TOWN CAR LEFT REAR SEAT BELT RETRACTOR INSPECTION

AFFECTED VEHICLES: CERTAIN 2000 MODEL YEAR TOWN CAR

FIGURE 1

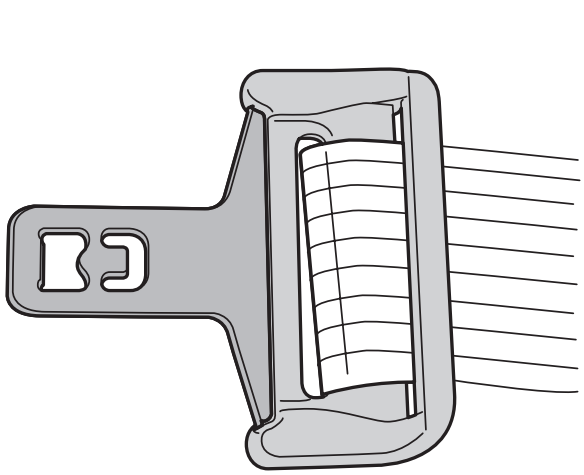
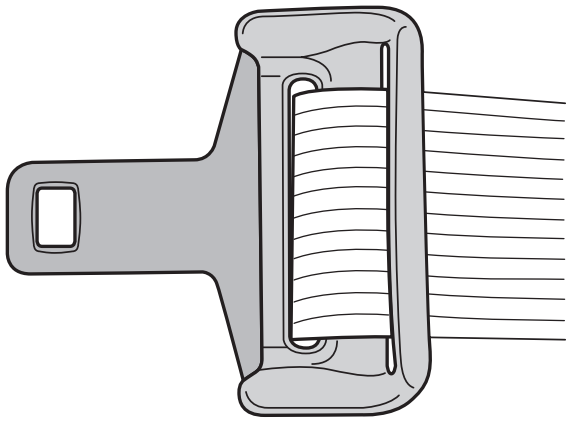
1. Inspect the left rear seat belt tongue. See Figure 1.
   - If the tongue is the two (2) hole design, replacement is ***not*** required. Release the vehicle to the customer.
   - If the tongue is the one (1) hole design, replace the retractor assembly. Follow the service procedure in section 501-20A of the appropriate Workshop Manual.

TWO (2) HOLE DESIGN
(CORRECT: DO NOT REPLACE)

ONE (1) HOLE DESIGN
(INCORRECT: MUST BE REPLACED)
